Service information

Reference no.: SDA_108804

Vibration and noise inside the machine Minuto family.

Up to SN **TW90144738196** tighten the screws in the boiler and boiler support (Image1)
Image1

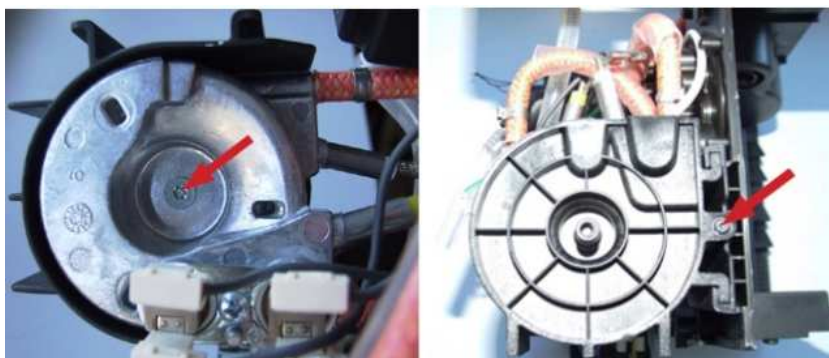
The boiler and boiler support fixing screw is not tight in the proper way. This is causing vibration and noise.

Check that the fixing screws both for the boiler and boiler support (Image1) are properly tightened from SN **TW90144738197**.
